NEW MEXICO  
ENVIRONMENT DEPARTMENT

**SUBJECT: SEPTEMBER 5, 2009 API SEPARATOR OVERFLOW REPORT  
WESTERN REFINING, SOUTHWEST INC., GALLUP REFINERY  
EPA ID NO. NMD000333211  
HWB-GRCC-MISC**

**RE: NOTICE OF DISAPPROVAL  
INTERIM MEASURES WORK PLAN TO COMPLY WITH RCRA STANDARDS  
FOR DISCHARGE OF WASTEWATER TO SURFACE IMPOUNDMENTS  
WESTERN REFINING COMPANY, SOUTHWEST, INC., GALLUP REFINERY  
EPA ID # NMD000333211  
HWB-GRCC-09-005**

SAMPLING PLAN  
(API OVERFLOW) ON 09/05/09

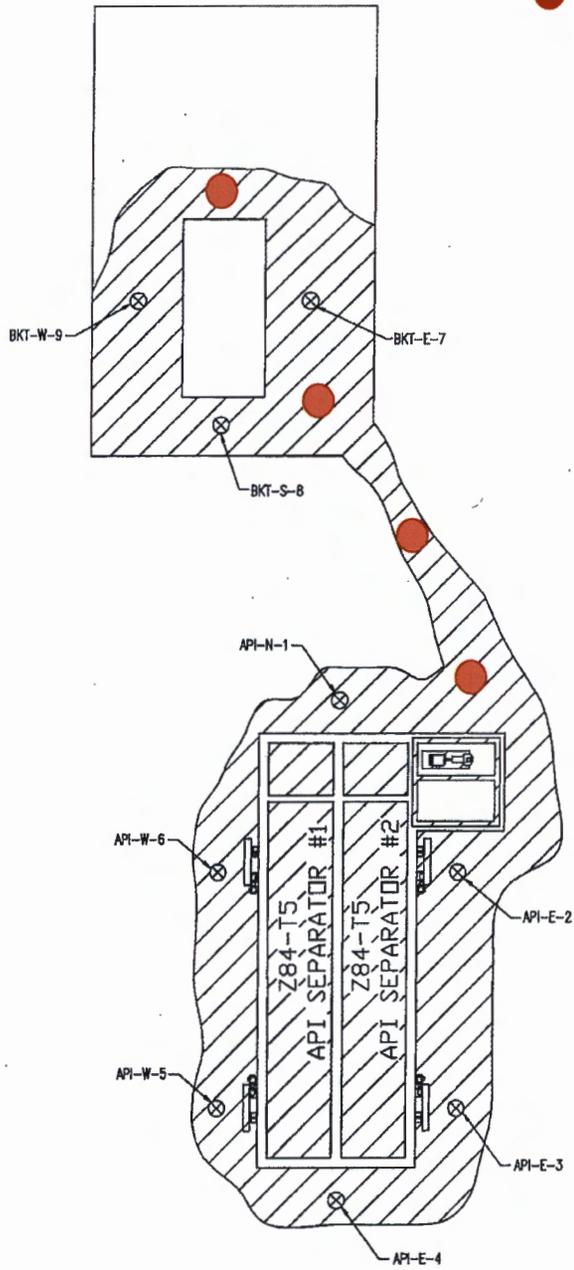
- a. The Permittee must remove additional contaminated soils in the vicinity of the API Separator and the Baker Tank within the hatched area identified in the "Sampling Plan" figure (attached).

- b. The Permittee must collect confirmation samples from the approximate locations of all of the former sampling locations with the exception the roll-off box location. The Permittee must also collect samples from the additional sample locations identified in the attached figure. All samples must be collected from the limits of the excavation not to exceed six inches in depth.

- c. All confirmation samples must be analyzed for DRO extended. In addition, samples collected from locations API-E-2 and BKT-E-7, BKT-S-8, and BKT-W-9 must also be analyzed for gasoline range organics.

- d. The confirmation samples must not exceed organics concentrations of 200 mg/kg, if such concentrations exceed 200 mg/kg then additional soil removal will be required until detected concentrations are less than 200 mg/kg.
